**ELECTRICITY ACT 1989
THE ELECTRICITY WORKS (ENVIRONMENTAL IMPACT ASSESSMENT) (SCOTLAND) REGULATIONS
2017
REQUEST FOR SCOPING OPINION FOR PROPOSED SECTION 36 APPLICATION FOR CARRICK
WIND FARM**

REQUEST FOR SCOPING OPINION FOR PROPOSED SECTION 36 APPLICATION FOR CARRICK WIND FARM

CARRICK WIND FARM SCOPING REPORT RESPONSE FROM DAILLY COMMUNITY COUNCIL

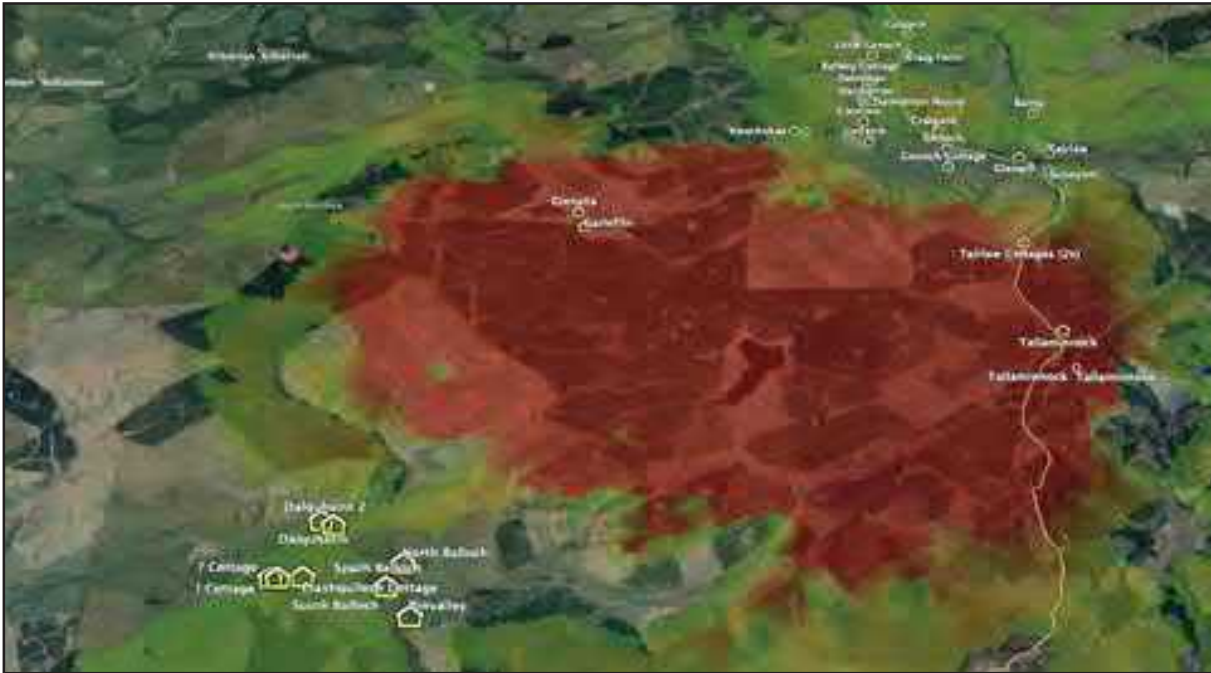
valley between Straiton and the proposed wind farm might be considered to have negative impacts due to the overbearing nature of the turbines, and south west of the site 8 properties between Balloch and Barr might also be similarly effected.

The following diagram illustrates this (red being categorically overbearing, green being found to be overbearing in some cases).

Additionally, it should be noted that the two roads which pass through the red overbearing zone include a National Cycle Route (7) which is effected for a distance of 3.5km and a tourist route through the Galloway Forest Park which is effected for 4.6km. Core paths and the Carrick Forest Drive also pass through the red zone.

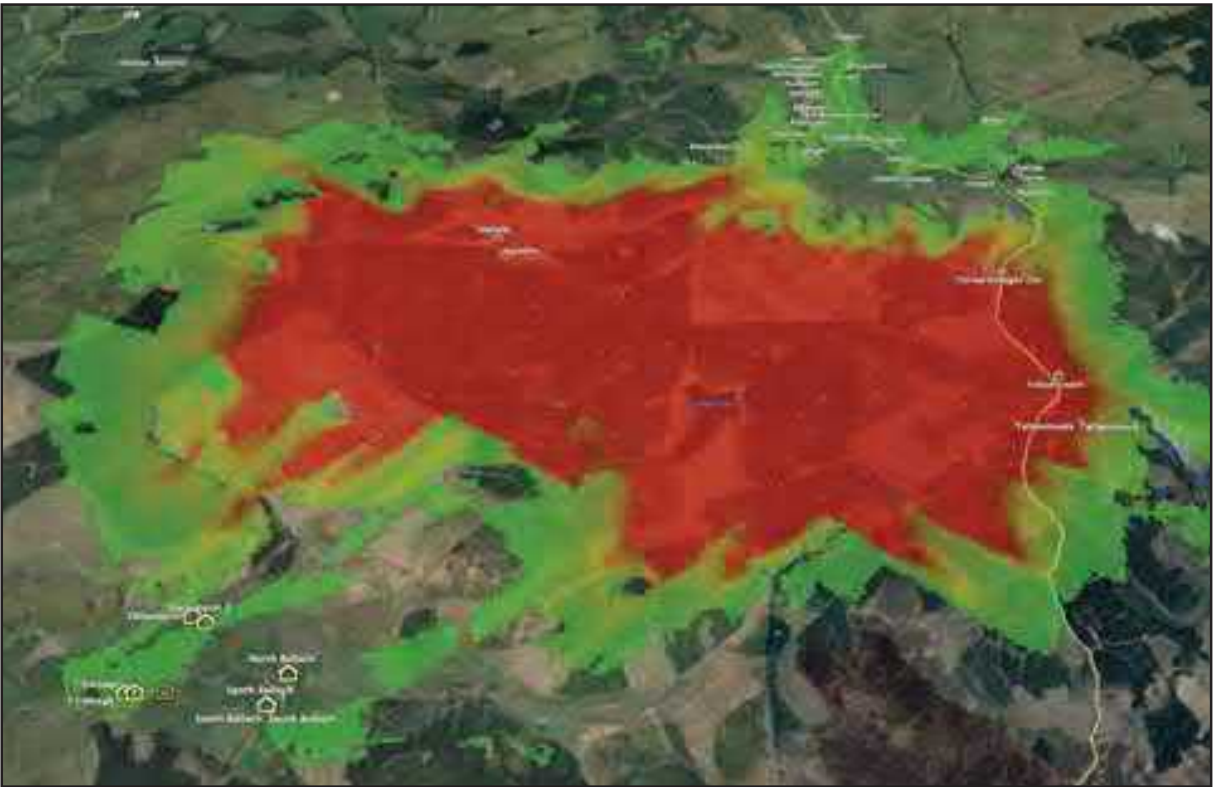
Whilst the scoping document does recognise this needs to be properly investigated, it is noted that they do refer to vegetation as a possible means of mitigation which is not only explicitly ruled out in planning advice but has also been found to intensify the flicker effect. The overall supply capability of the proposed development should be questioned if the alternate mitigation of switching off turbines when they potentially produce flicker: the severity is high enough to require 10-15% reduction in output.

Suggestion: when calculating Shadow Flicker the calculations should be extended beyond the problematic “10x turbine blade diameter” limit. We note that the Applicant has suggested they will extend this to 2.5km. Due to the topography of the landscape this should be extended to at least 6km (most wind farm modelling software is capable of this and, if not, it is not an expensive investment)

The following diagram shows the Shadow Flicker impact from unacceptable in red to problematic in green
